## RIX'S CREEK SOUTH CONTINUATION OF MINING PROJECT RESPONSE TO IPCN QUERIES FOLLOWING PROPONENT MEETING

On 9 July 2019, The Bloomfield Group (Bloomfield) met with the Independent Planning Commission (IPCN) to discuss the Rix's Creek South (RCS) Continuation of Mining Project (the Project) regarding the Development Consent Application (SSD 6300). This document responds to queries raised during the meeting.

**FIGURE 1**

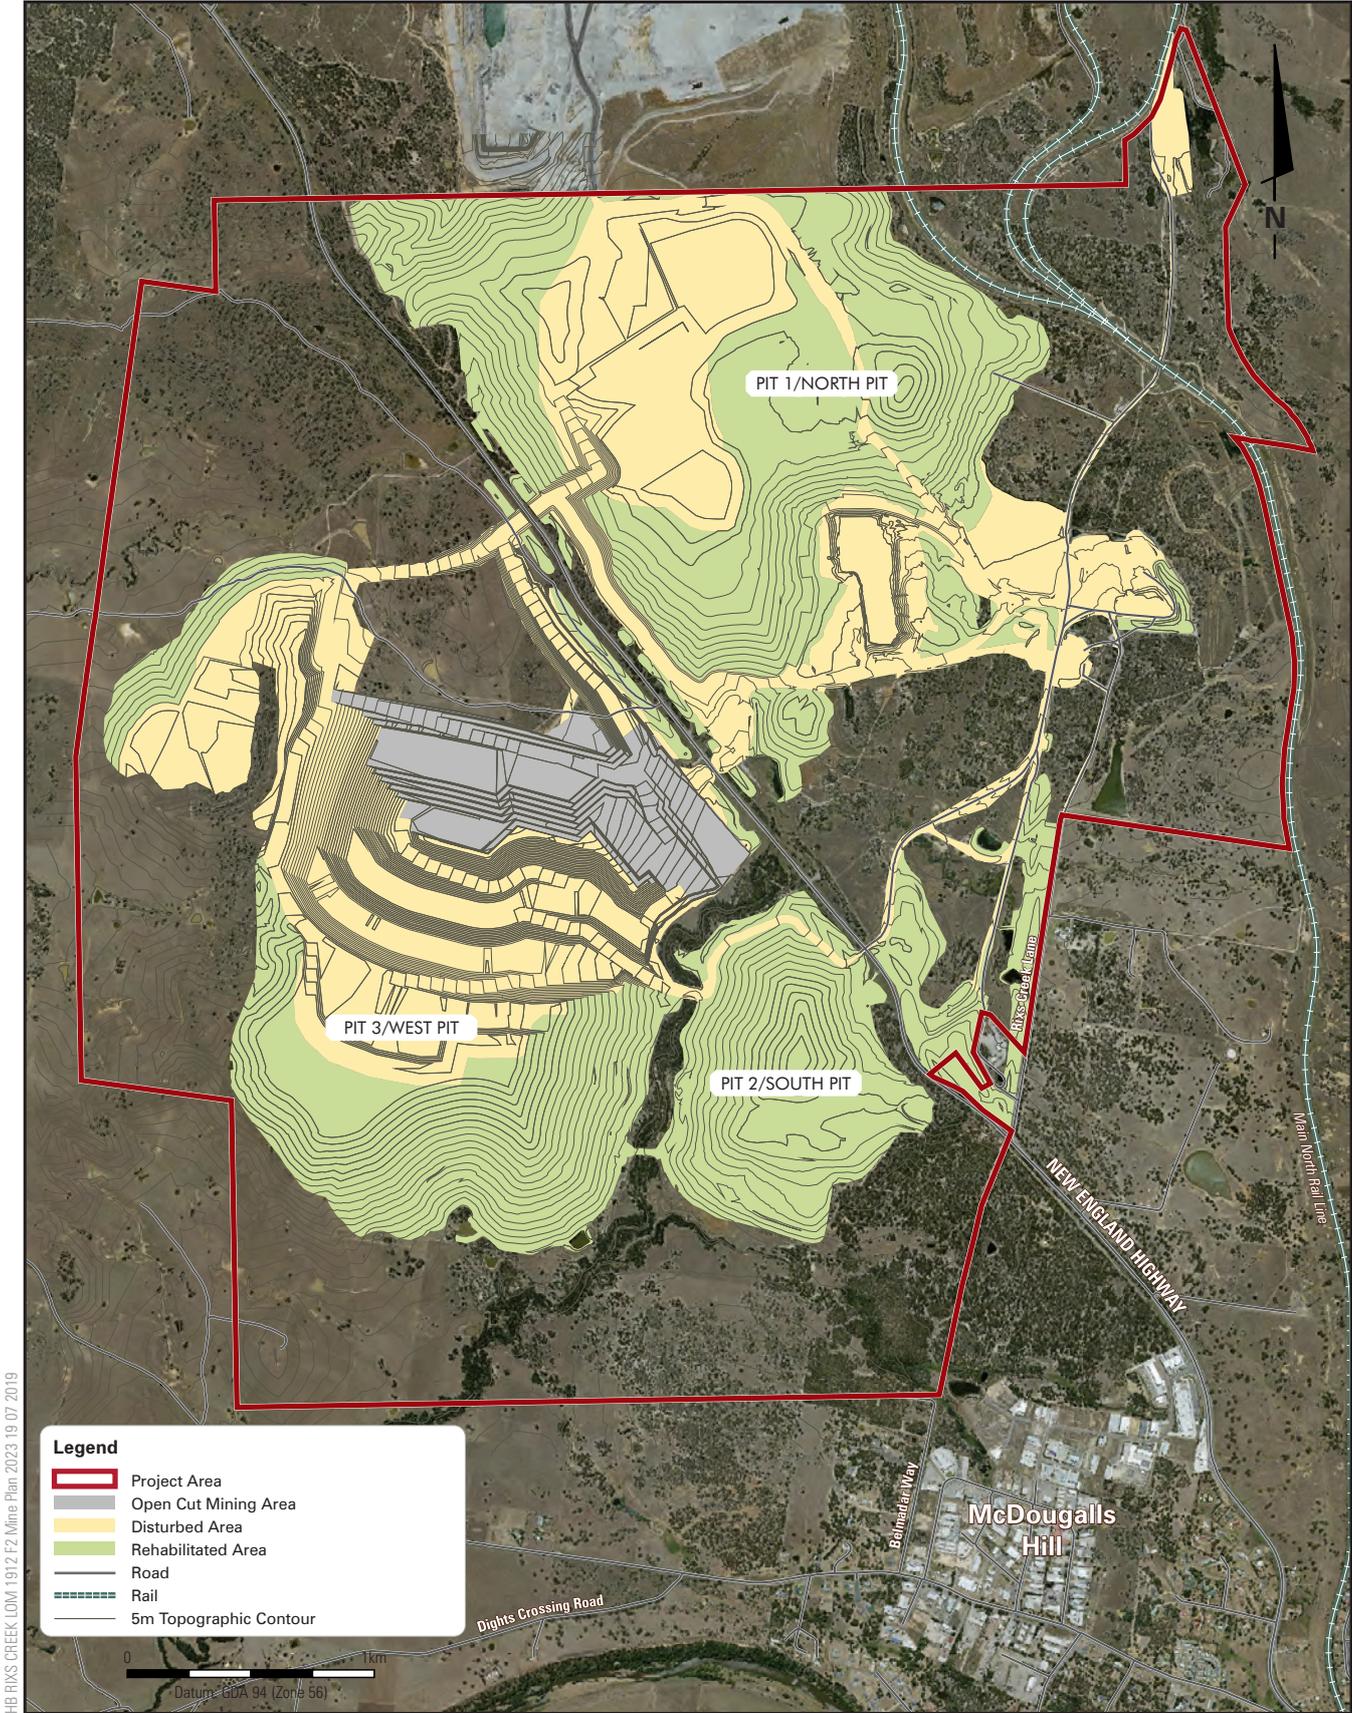
High wind speed will impact on emplacement at the high and exposed OEAs of the North Pit and South Pit as shown on **Figure 1**. Option 1 of the trade-off study would focus emplacement on these two OEAs. Option 2 utilises emplacement on these two OEAs and the new Western OEA (reduced in size from that proposed in the EIS).

The impact of strong winds on the mining operation would be highly dependent on whether an in-pit backfill location was available at the time strong winds were encountered. It is considered that the impact of high winds on Option 1 could see operations affected for up to 10 days per year (over five of the eight years that emplacement is active on the exposed North Pit OEA and South Pit OEA). Option 2,

until the later years, provides the flexibility of screened emplacement with the Western OEA and no loss of production is anticipated.
